E5061B-11

S E R V I C E N O T E

E5061B ENA Series Network Analyzer

E5061B LCD Touch Panel Display Assembly Replacement Part Change

Figure 2-11

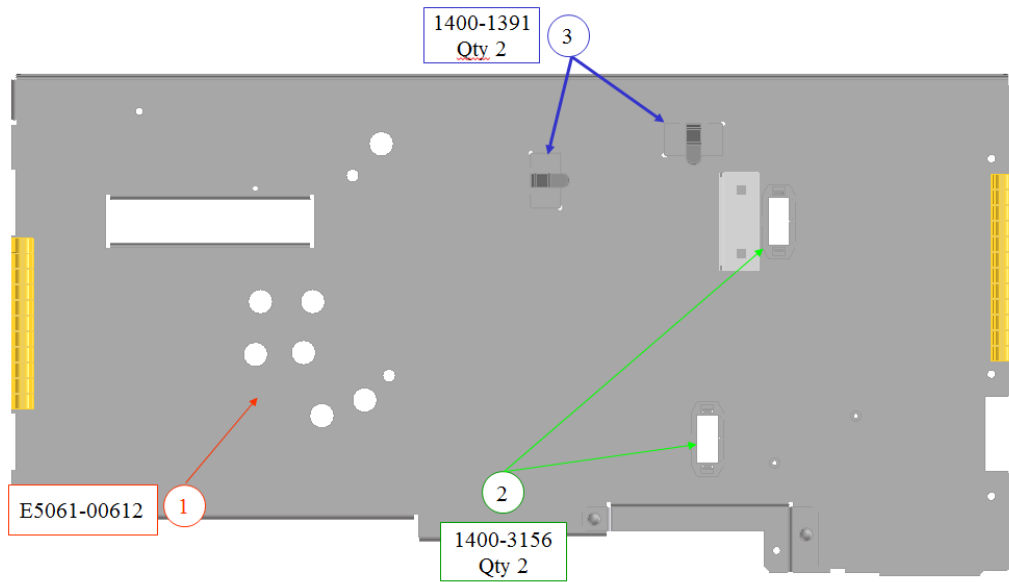
- 10. On the Front Panel back cover shield, install the cable clamp as shown in figure 2-11

Figure 2-12

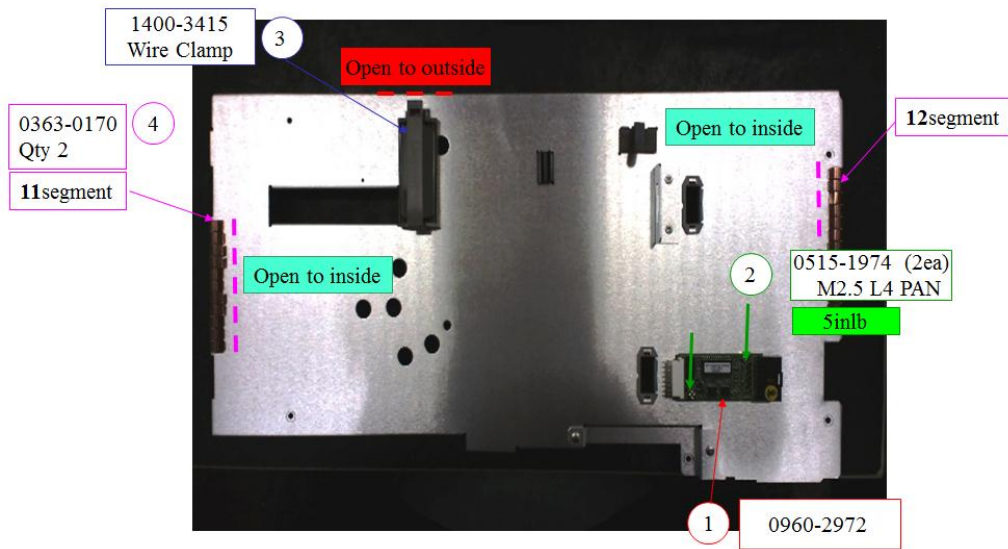
11. Install the cable clamps and Gasket (RFI fins) on the back cover as shown in figure 2-12.

Figure 2-14

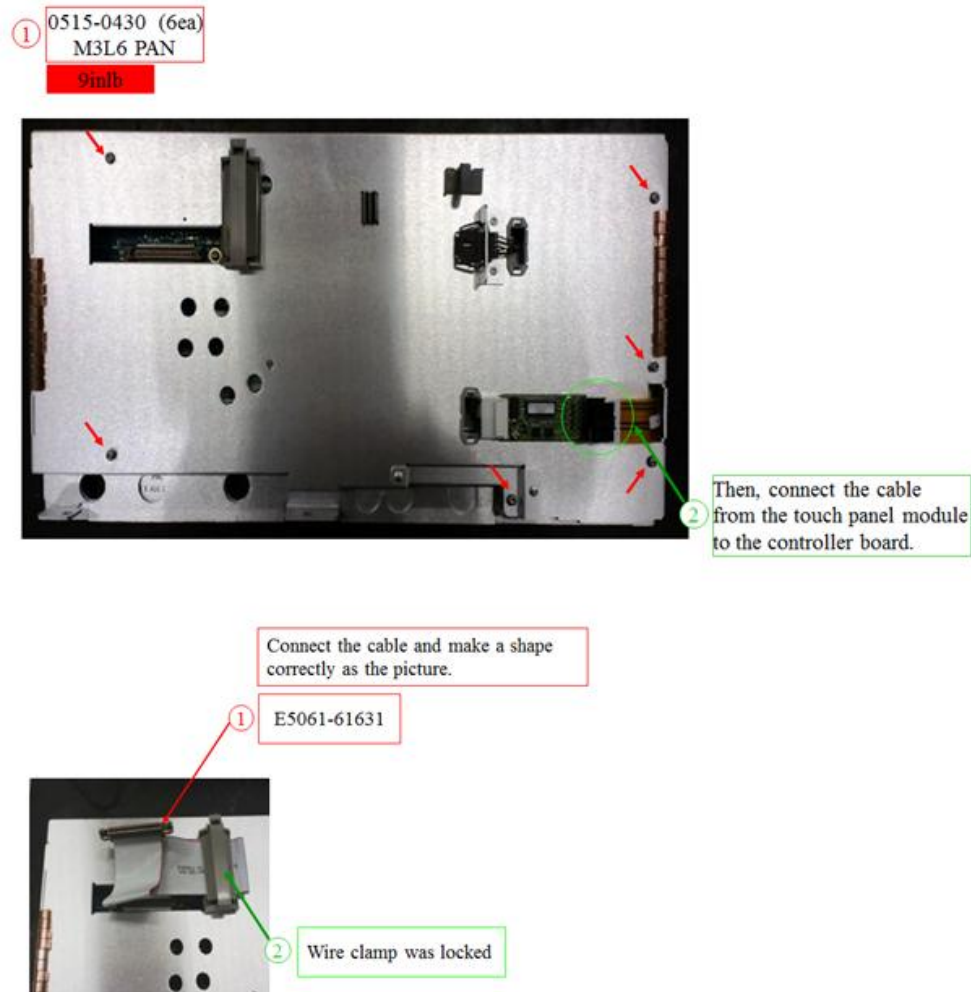
13. Shown would be the completed installation of the assemblies. Kindly ensure the connections of the cable assemblies are good and properly secured. Fasten the six screws in securing the shield (back cover) to the Front Panel Assembly. Refer to figure 2-14 for details.
